Job Sheet 166065

Part Name: Lower Deflector Low

ENGINEERING CHANGE NOTICE NO. 03828

DWG NO. 646.9800

SHEET 1, ZONE A5-A6 & B5-B6 WAS:

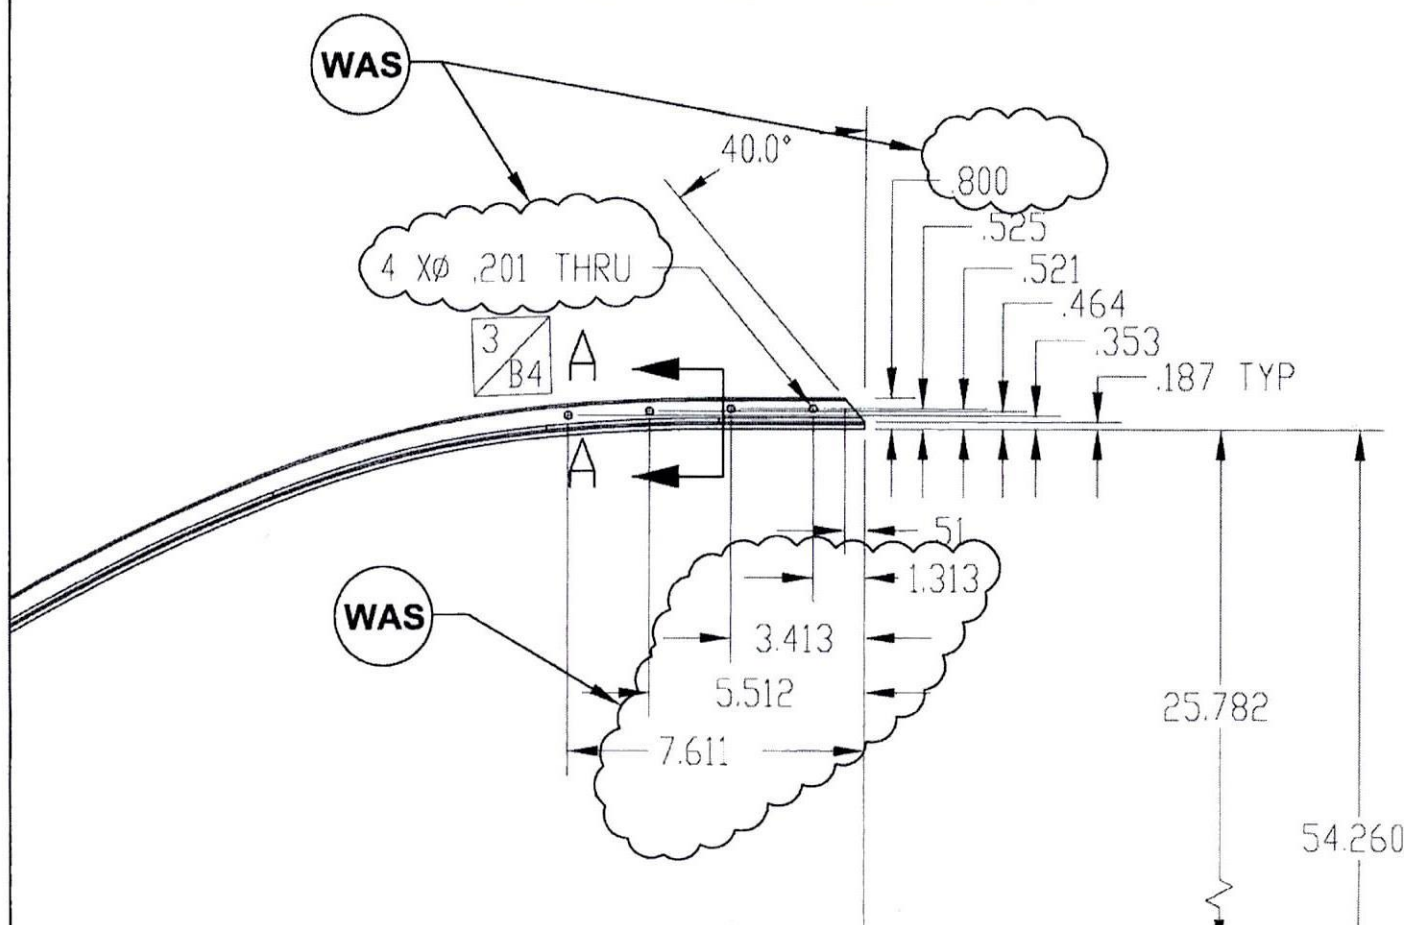
REVISED CORNER RADIUS, TOLERANCES, AND ADDED INSPECTION DIMENSIONS.
